# CITY PLANNING COMMISSION

- Negative Declaration
- 2. Special Permit to exceed the 25 percent office use to allow the development of a 40,180 sq. ft. office building on 1.6+ vacant acres in the Heavy Industrial (M-2(S)) zone

LOCATION: Southeast corner of Kiefer Boulevard and Florin-Perkins Road

P89-275

EXHIBIT FLEVATIONS

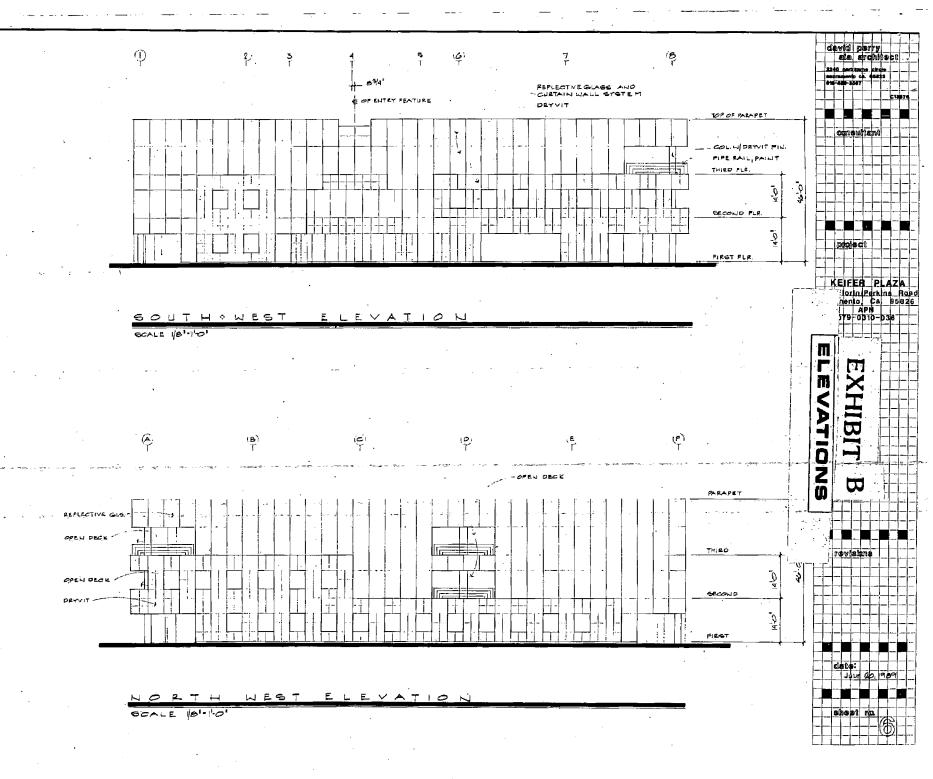
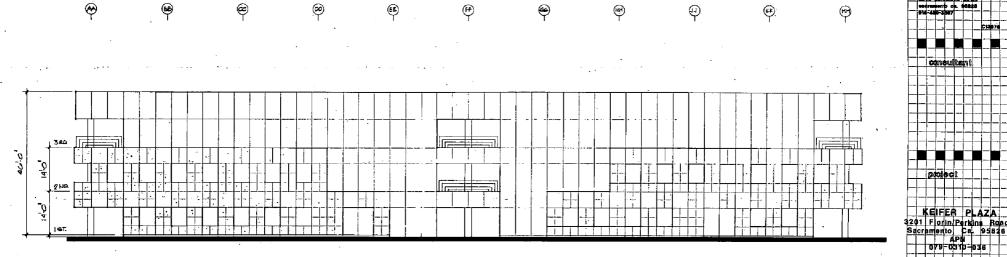
The proposed building design consists of reflective glass and dryvit with a built-up roof. The building height is 46 feet with three floors. Building area on the three floors will be 11,500 square feet, 14,300 square feet, and 14,380 square feet, respectively. Staff supports the overall building design but would prefer a metal circular column natural finish in aluminum to match with the horizontal curtain wall or painted metal to match the color of the railing. The reveal lines should be wide and deep to present a well defined shadow line.

Interior of the parapet wall shall be finished in a manner equal to the exterior surface of the building.

- 9. The parking area shall be required to meet the 50 percent shading requirement.
- Reveal lines shall be wide and deep to present a well defined shadow line.

11. The interior of the parapet wall shall be finished in a manner equal to the exterior surface of the building.
